## **SOILS AND GEOLOGY STUDY**

**The Ridge at Lorson Ranch  
El Paso County, Colorado**

**JOB NO. 175706**

**March 22, 2021**

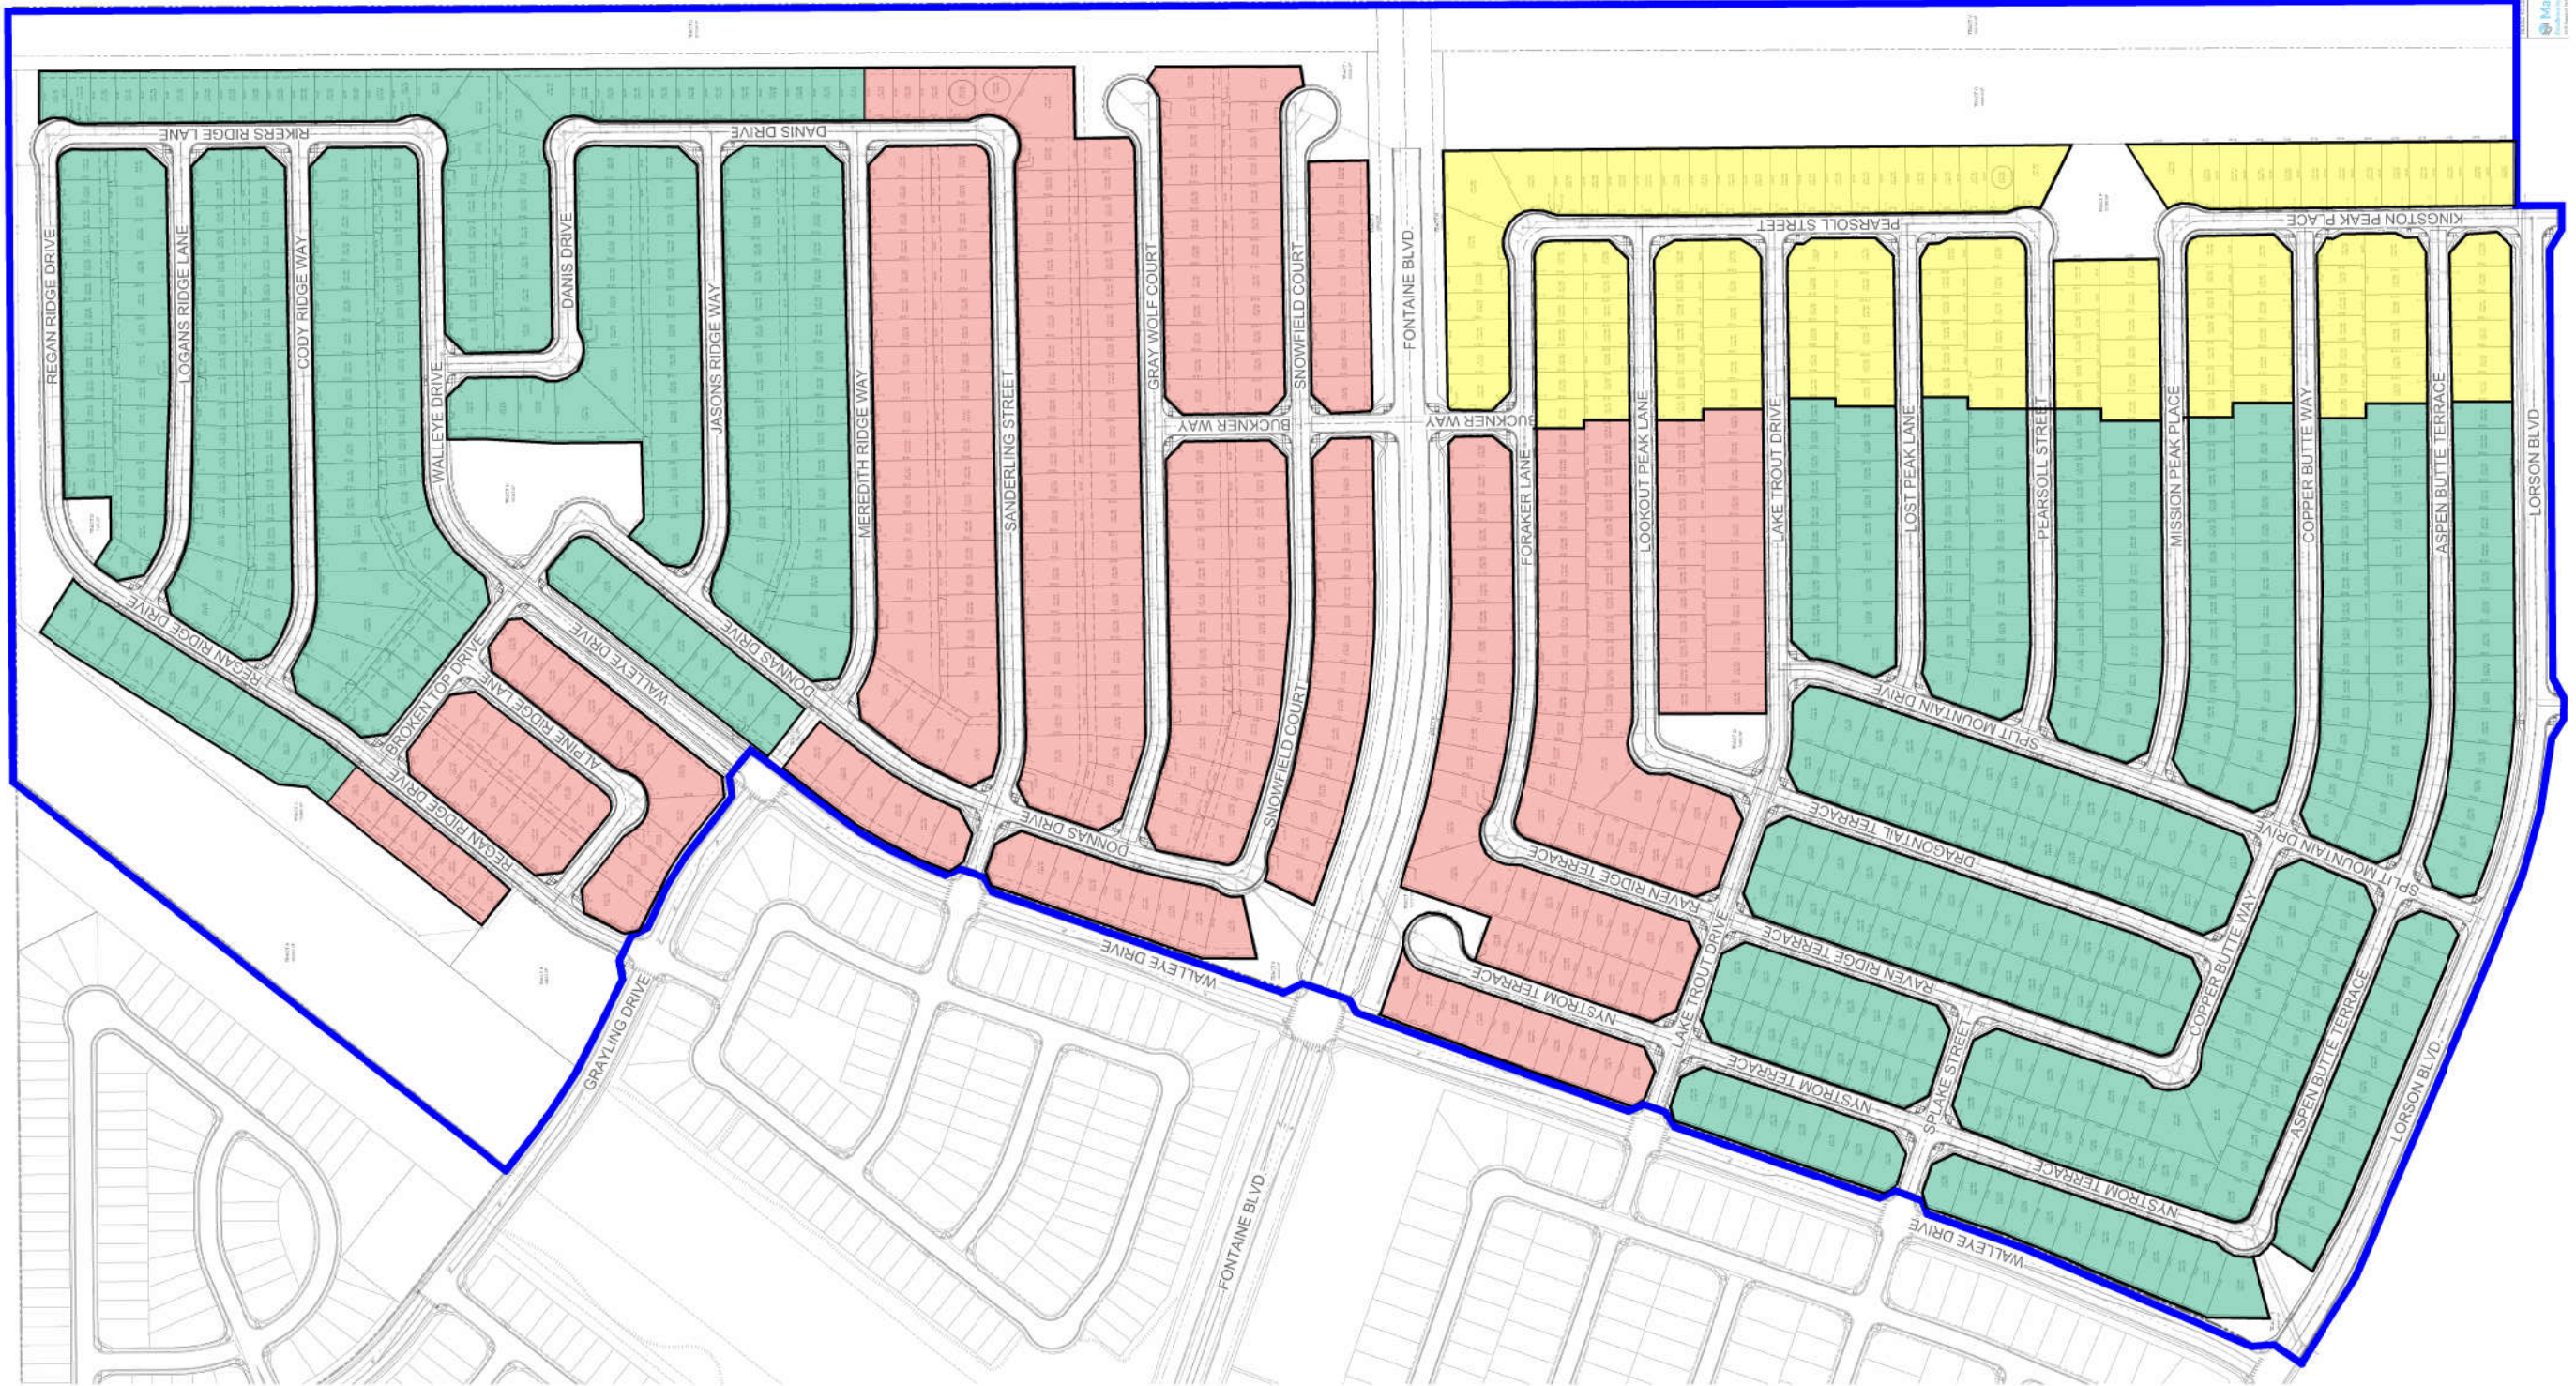
verify this matched grading plan
